SERVICE BULLETIN 0807-001
8-21-20, Revision C

MULTI-GROOVE SUPERCHARGER BELT

Figure 1

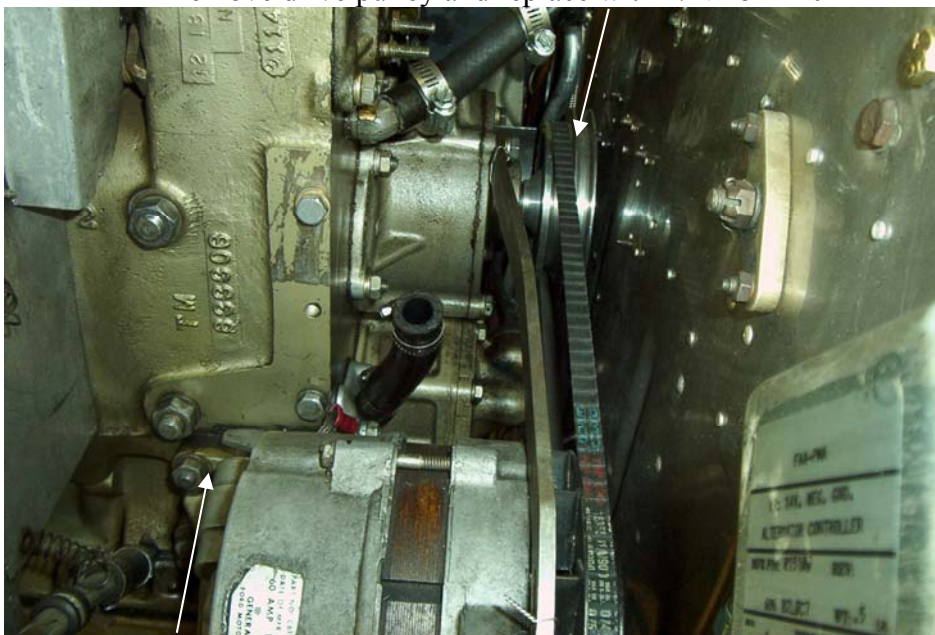
5. Reinstall the modified alternator support and alternator.
6. Remove the alternator/supercharger drive pulley from the rear of the engine and replace it with the new double pulley, P/N182LR014-2 or 182U014-2, using the existing hardware. Tighten to 37.5 to 41.2 ft. lbs. (Figure 1)

7. Reinstall the alternator belt, FAT P/N 182355, and tighten the belt by rotating the alternator. (Figure 1)
8. Remove the supercharger pulley (figure 2) and replace it with pulley P/N 182LR009-2 using the existing hardware.

Remove drive pulley and replace with P/N 182LR014-2

Figure 2

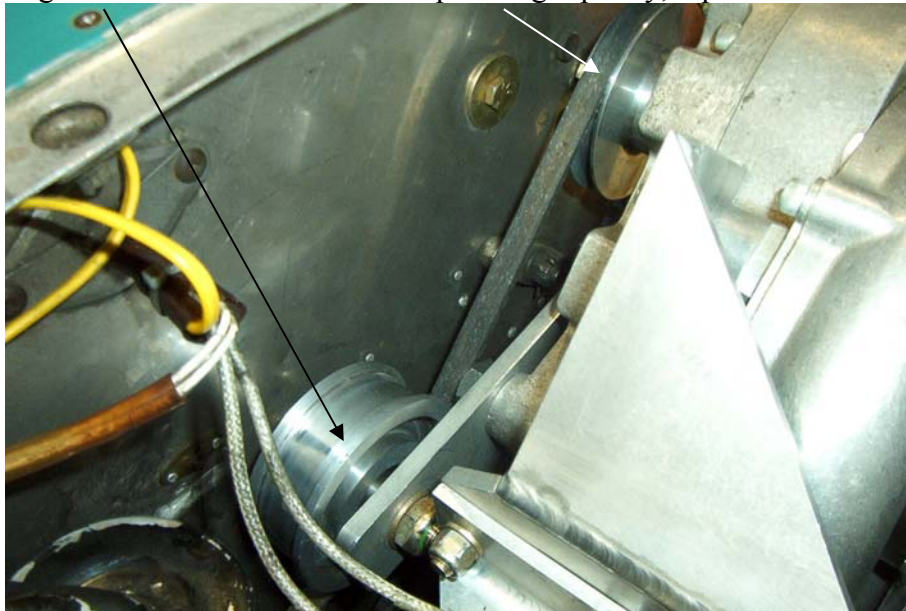
Remove supercharger pulley, replace with P/N 182LR009-2
